**Subject:** Corridors in Historic Highrise Apartment Buildings and Hotels

- Applicable Standards:**
- 2. Retention of Historic Character
  - 5. Preservation of Distinctive Features, Finishes and Craftsmanship

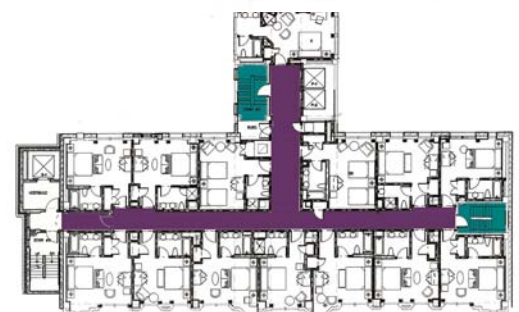
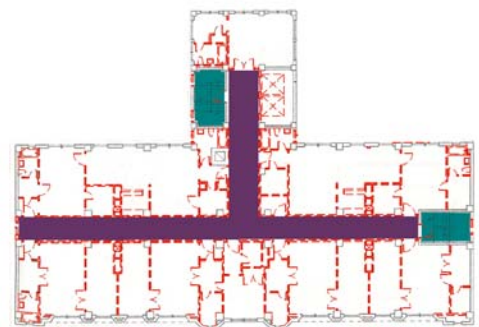
**Application 1** (*Incompatible treatment*): Completed in 1926, this ten-story brick and terra cotta building was originally an apartment hotel (“bachelor” apartments without kitchenettes on the first floor and efficiency apartments on the remaining floors). Eventually, it was converted to hotel use only. The building is distinguished by virtually intact historic fabric and floor plans, including a T-shaped, double-loaded corridor system on floors two through ten. The rehabilitation proposal calls for gutting of these floors, which are in excellent condition, and construction of new corridors and hotel rooms. While the new corridor system would essentially reproduce the shape of the historic corridor system, the proposal to completely eliminate intact, character-defining features, finishes and spaces, including the apartment layouts, does not meet the Standards.

*TOP RIGHT: Proposed demolition plan for each of the upper floors. Red, dotted lines indicate removal of original corridor and room partitions with the historic trim and detailing.*

*BOTTOM RIGHT: Proposed plan for the upper floors. The longer section of the new corridor is narrower than its historic counterpart. All finishes, detailing and trim would be imitations of the original.*

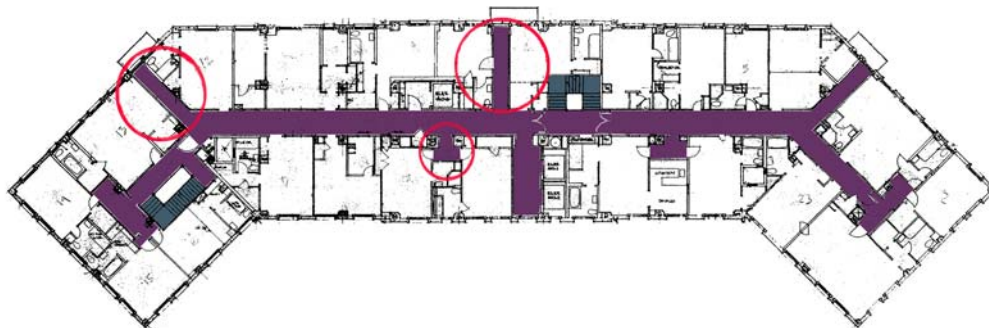
**Application 2 (Compatible treatment):** Opened in 1927 to serve as an apartment hotel (originally, 85 apartment suites and 32 hotel rooms), this building is a fifteen-story, reinforced-concrete tower. Over the years, virtually all of the building became a hotel. Then, as part of the recent rehabilitation, the building shifted back to apartment building use. Above lobby level, the floors are served by double-loaded corridors that follow the footprint of the wide central section of the building and its diagonal end wings. The rehabilitation retained the elevator lobbies, corridors, and the associated historic fabric, with a few minor modifications (the basic room configuration was also retained, with some grouping of rooms to create apartments). Two small corridor “access ways” for fire escapes were converted to private space for adjacent apartments (as the fire escapes themselves were eliminated); drywall was laminated to the deteriorated plaster walls (historic trim and detailing were retained); and a drywall ceiling was dropped slightly below the historic flat plaster ceiling to accommodate the new mechanical, electrical and plumbing systems. This work preserves the historic character of the corridors and, thus, meets the Standards.

*RIGHT: Post-rehabilitation view of typical corridor showing retention of historic trim, drywall finishes that match the appearance of the original flat plaster, and a slightly lower ceiling that conceals new systems. Also shown are a compatible, largely glazed fire door and a portion of the preserved open stair (lower left of image).*
